**URGENT FIELD SAFETY NOTICE
UPDATED**

Philips EPIQ & Affiniti Ultrasound Systems
System Lock-Up Issue and PW Doppler
Signal Dual Mode Issue

04 - OCT - 2021

Figure 1

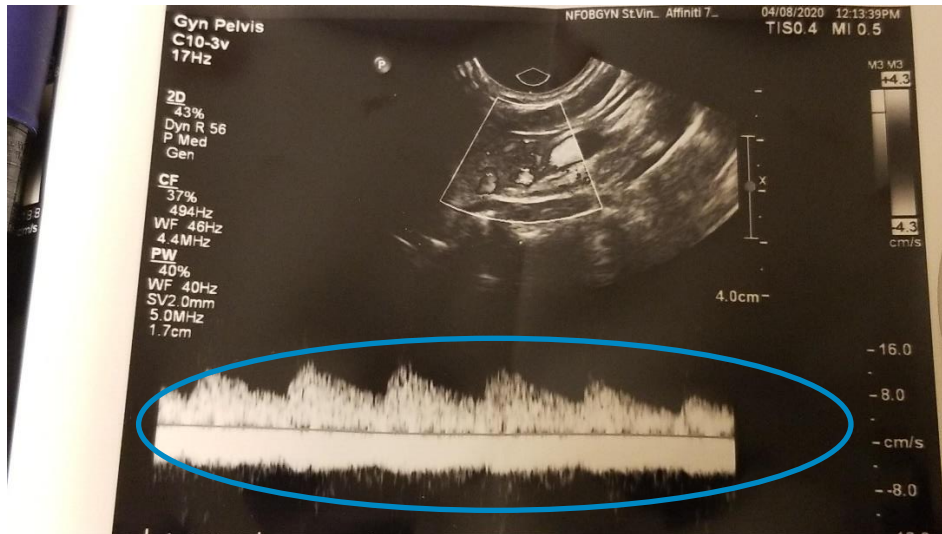
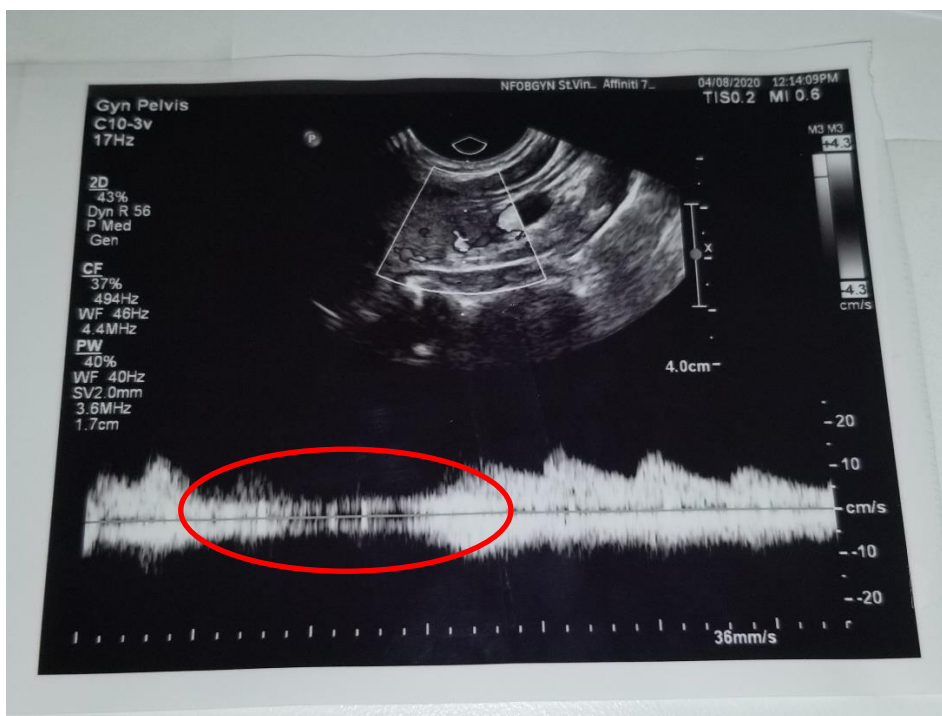
Philips Ultrasound has identified an issue where the Pulse Wave (PW) Doppler signal, both visual and

audio can be compromised under specific workflows.

Figure 1 shows a normal PW Doppler signal, highlighted in the blue oval. When the issue occurs, this signal is compromised as shown in Figure 2 below, highlighted by the red oval.

The issue occurs if a user enters Dual Mode, exits Dual Mode and then turns on the PW Doppler signal. The PW Doppler signal cannot be engaged while in Dual Mode, so the user must leave this Mode to use PW Doppler. At this point, having been in Dual Mode creates the issue in the PW Doppler Signal.

The PW Doppler function can be used prior to entering Dual Mode. This avoids the issue by **preventing** the Dual Mode from impacting the use of the PW Doppler function.

- 1) The user can reselect the transducer after exiting Dual Mode which will resolve the issue in the signal allowing normal use of the PW Doppler function. Note, this mitigation would need to be used each time the user goes into and exits Dual Mode. Note, any function which reselects the transducer, such as closing and opening the exam will also solve the problem.
- 2) The user can validate their PW Doppler signal using a different Doppler Mode such as Color Doppler. Color Doppler is not affected by this issue. Note, Color Doppler is a different clinical function. However, its output correlates to the PW Doppler output to indicate to the user there is a problem.
